DART AEROSPACE LTD		Work Order:	159220
Description: Crosstube Assembly, Mid Aft		Part Number:	D206-667-247
Inspection Dwg: D206-667-247 Rev: A		Page 1 of 2

DART AEROSPACE LTD HAWKESBURY, ONTARIO, CANADA	
DRAWING NO. D206-667-247	REV. A SHEET 1 OF 4
TITLE CROSSTUBE ASS'Y (206L MID AFT)	SCALE NTS
COPYRIGHT © 2010 BY DART AEROSPACE LTD THIS DOCUMENT IS PRIVATE AND CONFIDENTIAL, AND IS SUPPLIED ON THE EXPRESS CONDITION THAT IT IS NOT TO BE USED FOR ANY PURPOSE OR COPIED OR COMMUNICATED TO ANY OTHER PERSON WITHOUT WRITTEN PERMISSION FROM DART AEROSPACE LTD.

DRAWING NO. D206-667-247	TITLE CROSSTUBE ASS'Y (206L MID AFT)	REV. A	DART AEROSPACE LTD ENGINEERING ORDER		D.E.O. NO. D206-667-247-A-1	SHEET NO. SHEET 1 OF 1	SCALE NTS
DRAWN <i>q2</i>	CHECKED <i>ASS</i>	MFG. APPR. <i>KB</i>	APPROVED <i>IMP</i>	DE APPR. <i>TH</i>			
DATE 11.07.15	DATE 11.07.20	DATE 11.07.21	DATE 11/07/21	DATE 11.7.21

PURPOSE:

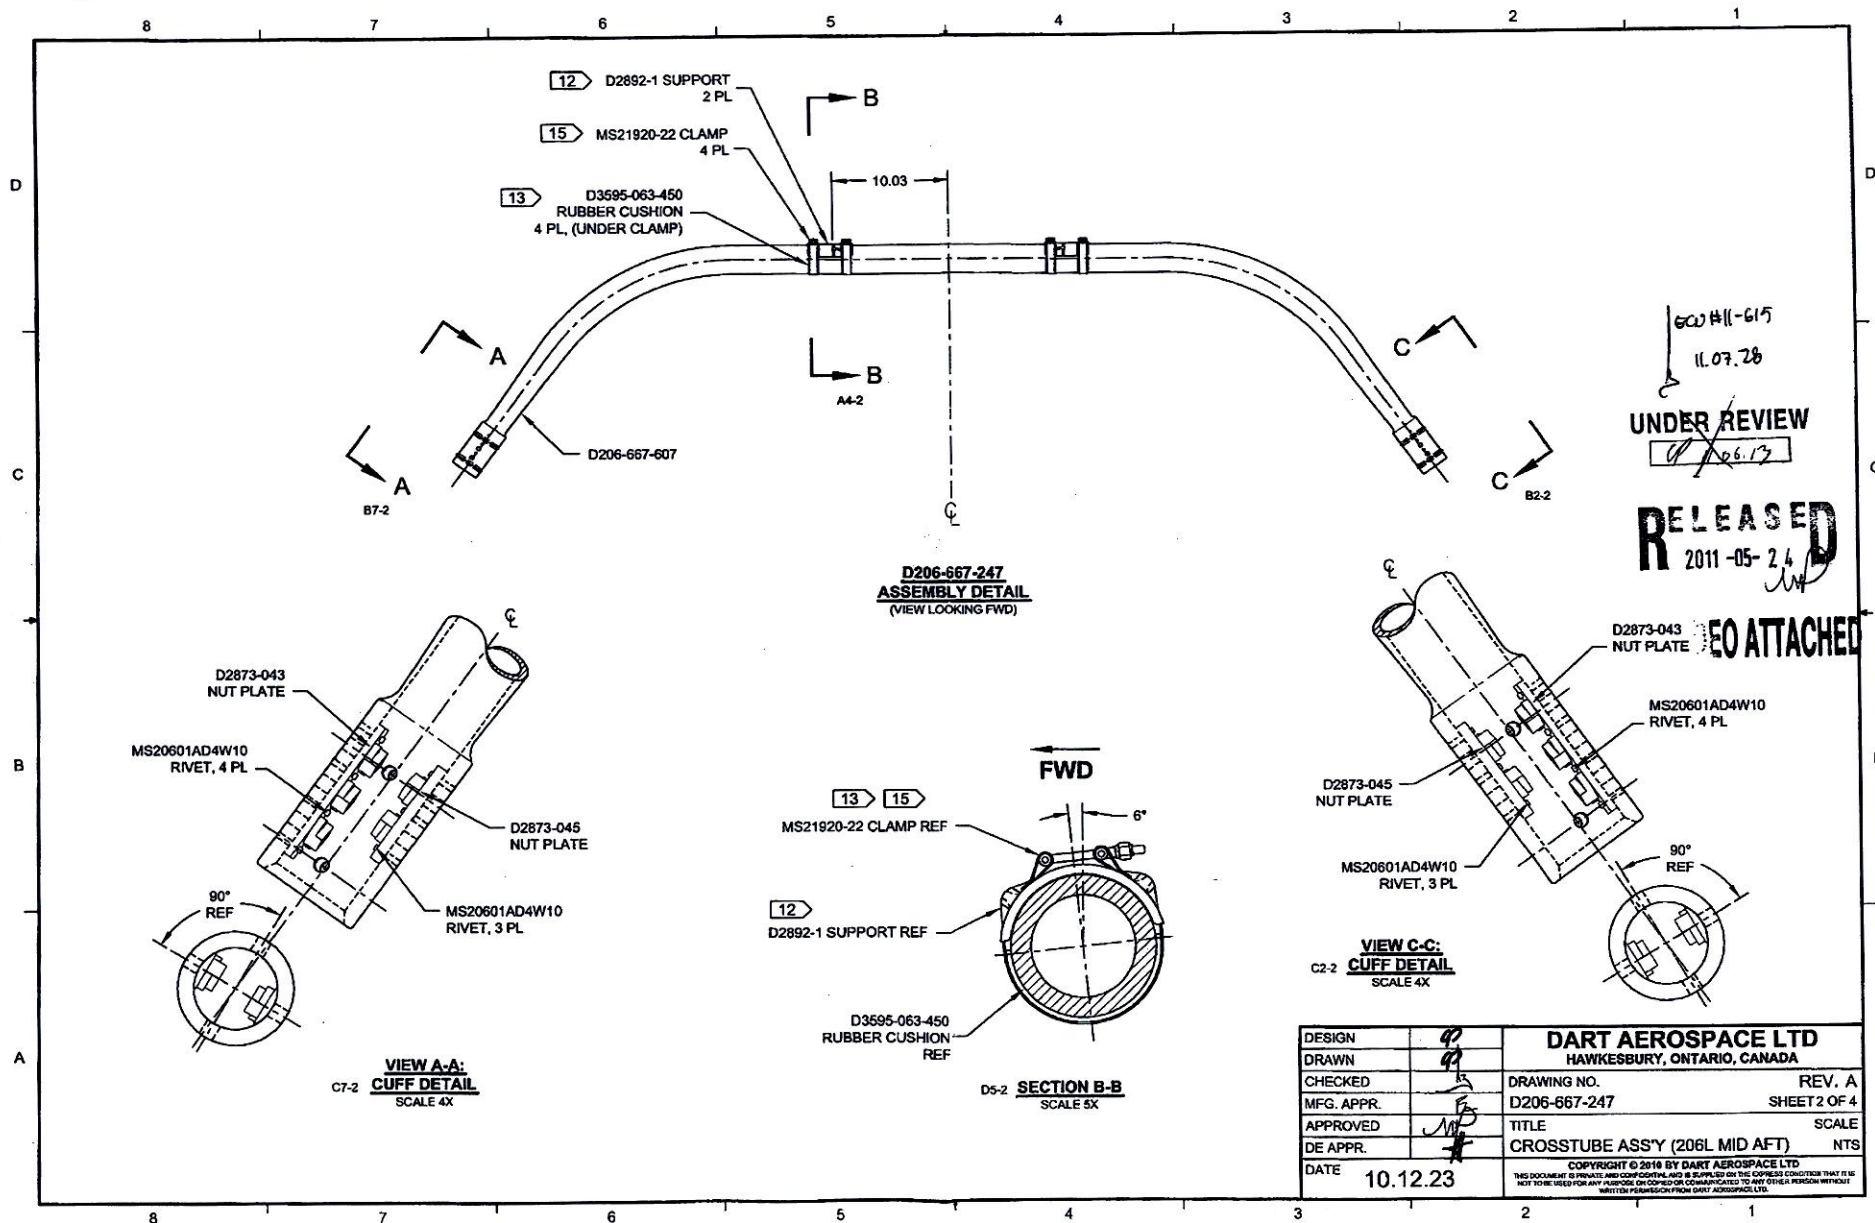
REPLACE MAGNOBOND WITH PROSEAL.

IS:

Item	Qty -247	Part Number	Description
9	A/R	PROSEAL 890 B-2	SEALANT, AMS-S-8802 CLASS B-2

WAS:

9	A/R	MAGNOBOND 6398	ROCKWELL SPECIFICATION RBO-120-023 ADHESIVE (TEXTRON/BELL SPEC. 299-947-100, TYPE II, CLASS 2 ADHESIVE)
---	-----	----------------	---

NOTE 12 & 15, SHEET 1 IS AMENDED AS FOLLOWS:

- 12) TO INSTALL D2892-1 SUPPORT: ABRASE MATING SURFACE OF SUPPORT AND CROSSTUBE WITH 180-GRIT SANDPAPER AND REMOVE RESIDUE WITH MEK (OR EQUIVALENT). APPLY A 0.04" TO 0.07" THICK LAYER OF PROSEAL 890 CLASS B-2 (OR AMS-S-8802 CLASS B-2) SEALANT TO MATING SURFACE OF SUPPORT.
- 15) TORQUE CLAMPS 80 TO 100 IN-LB. ENSURE AT LEAST 1.5 THREADS SHOWING IN SAFETY AND THAT NUT HAS NOT BOTTOMED-OUT AFTER TORQUING. **PRIOR TO PACKAGING, RE-CHECK TORQUE ON CLAMPS AFTER PROSEAL 890 SEALANT HAS CURED FOR 72 HOURS.**

- 12) INSTALL D2892-1 SUPPORT USING 0.03" TO 0.06" THICK LAYER OF MAGNOBOND 6398 PER QSI 015. LET CURE FOR 12 HOURS AFTER INSTALLATION AND PRIOR TO PACKAGING.
- 15) TORQUE CLAMPS 80 TO 100 IN-LB. ENSURE AT LEAST 1.5 THREADS SHOWING IN SAFETY AND THAT NUT HAS NOT BOTTOMED-OUT AFTER TORQUING.
